THE CITY OF KEY WEST
3140 Flagler St,
Key West, FL 33040

ADDENDUM #1
Mallory Square Electrical Upgrades
Project: FM1301
Invitation to Bid: ITB 15-005
May 27, 2015

ADDENDUM #1
Mallory Square Electrical Upgrades
Project: FM1301
Invitation to Bid: ITB 15-005
May 27, 2015

1 Typical Trench Detail
NTS

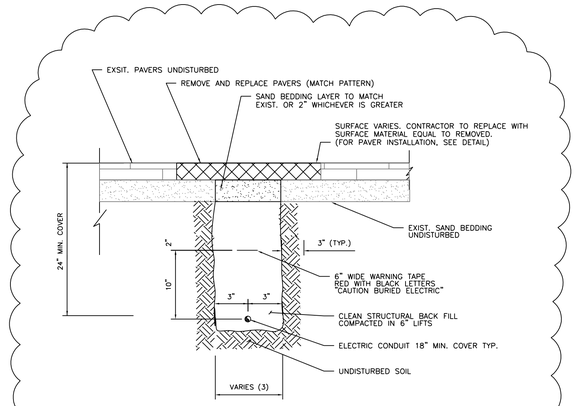
1. The attached sign-in sheet provides information on the attendees of the mandatory pre-bid meeting.
2. The attached drawing C-2 revised May 21, 2015 shall replace the Sheet C-2 in the original construction drawing set. The typical trench detail has been modified to delete flowable fill.

PEDESTAL DETAIL A – BASE BID

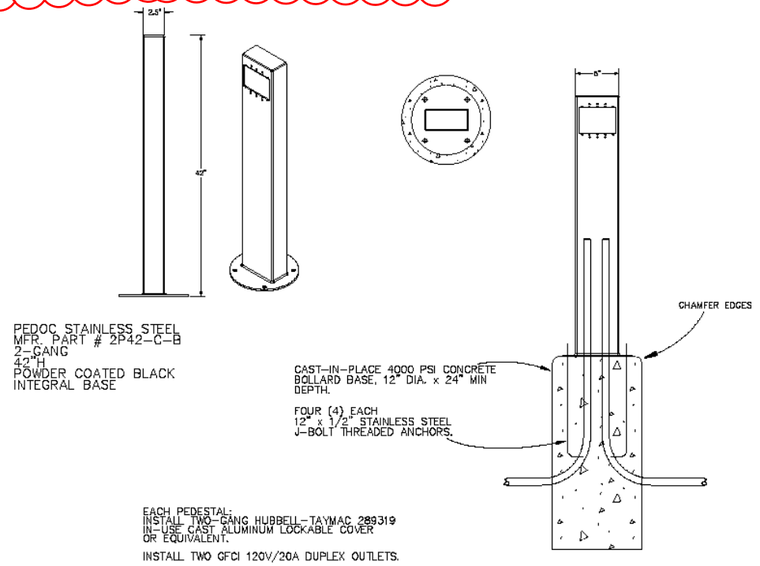
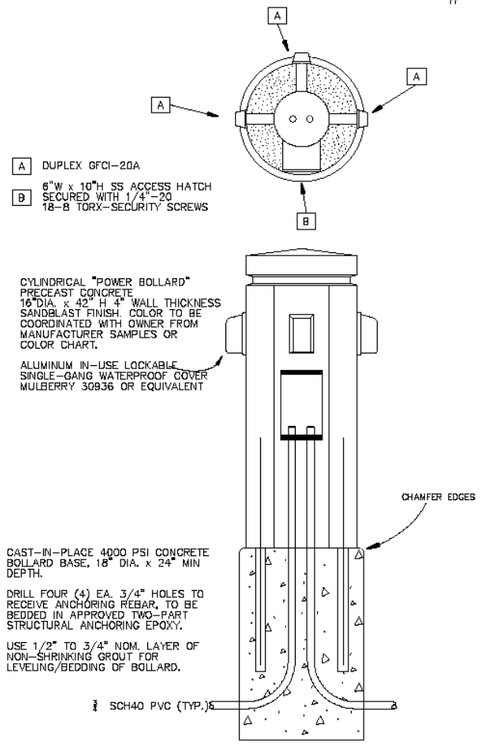
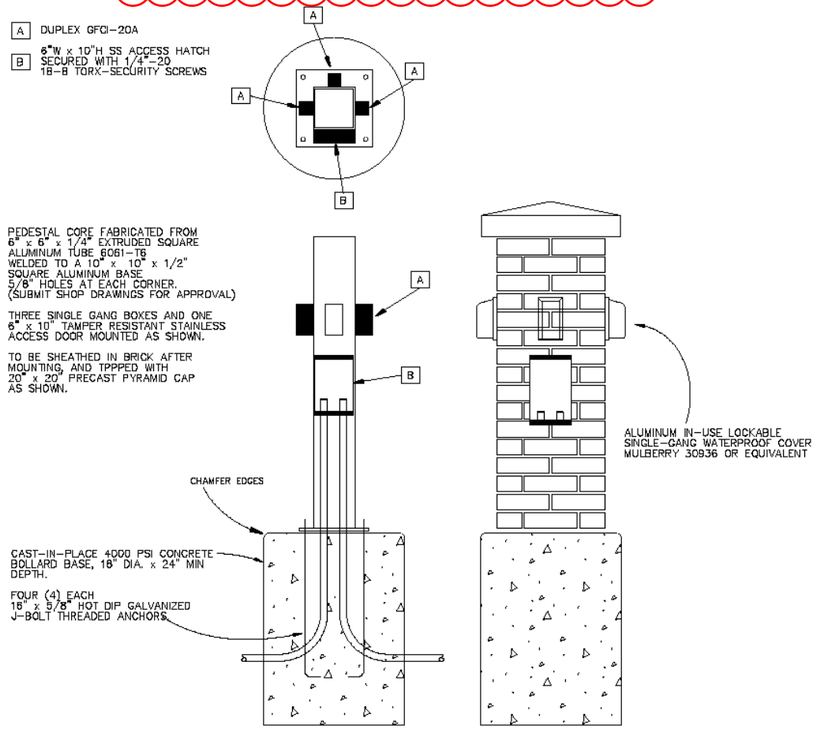
3. The attached drawing E-1 revised May 21, 2015 shall replace Sheet E-1 in the original construction drawing set. The drawing has been modified to indicate that the "PEDOC" powder-coated, stainless steel pedestal (Detail 'A') is now specified for the base bid while the precast concrete pedestals and aluminum/brick pedestals are bid alternates #1 and #2, respectively.

NEW WORK POWER RISER DIAGRAM

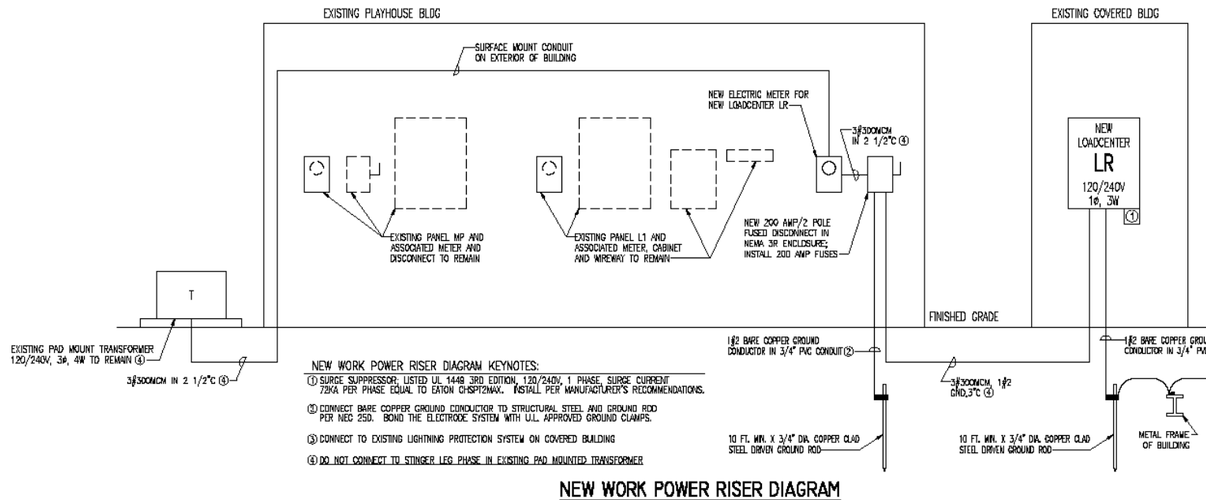
Q Sheet E-1: How will conduits be attached to the Waterfront Playhouse building?

A Stainless steel unistrut, straps and tapcons shall be used. Conduit shall be installed in accordance with Article 352 of the NEC 2011 Edition.

JOB NO. 141017
DRAWN RQY
DESIGNED RQY
CHECKED RQY
QC
SHEET E-2

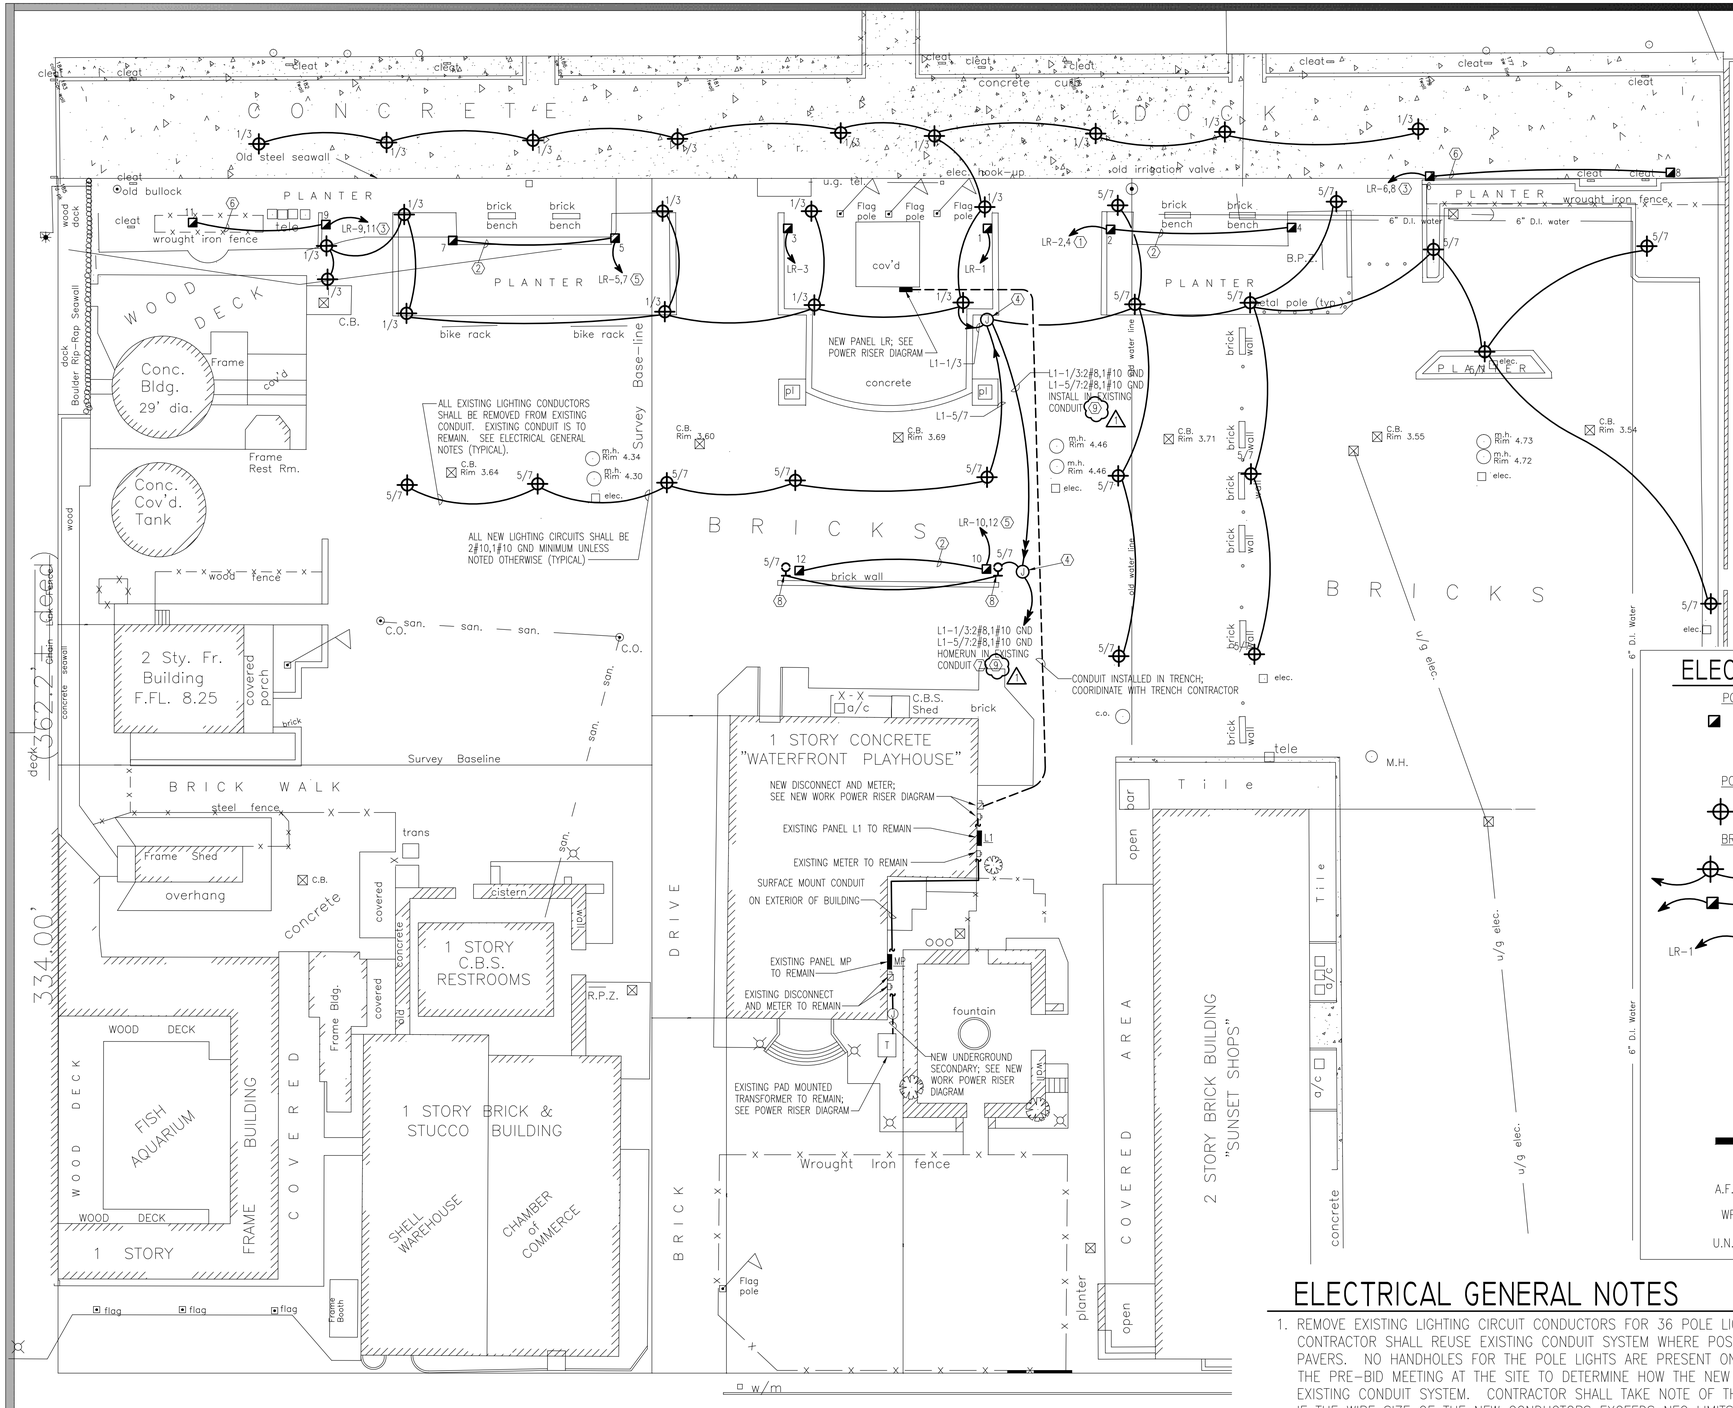
4. The attached drawing E-2 revised May 21, 2015 shall replace Sheet E-2 in the original construction drawing set. The revised drawing details replacing underground junction box 'J' with an 18"wide x 30" long x 18" deep composite box and stipulating that no below-ground splices allowed on this project.

Q Sheet E-2. Is it an option to replace/enlarge Junction Box 'J'?

Q Sheet E-2. Is it an option to run new conduits in the proposed trench to allow for home-runs for lighting circuits?

Q Sheet E-2. Can more detailed information be provided on the proposed pedestal locations?

Q Sheets E-1 and E-2. Where will rigid conduit be used?

A Yes. Note that a revised Sheet E-2 (which calls for replacement of 'J') is included in Addendum #1.

A Yes. Refer to revised Sheet E-2 included in Addendum #1.

A Pedestal and conduit trench locations will be field located by the Contractor in locations approximate to those shown on Sheet E-2. Locations will be subject to approval by the Owner prior to installation or excavation.

A No metallic conduit shall be used, above or below-ground. All proposed conduits, bends and fittings shall be SCH80 UV-resistant PVC.
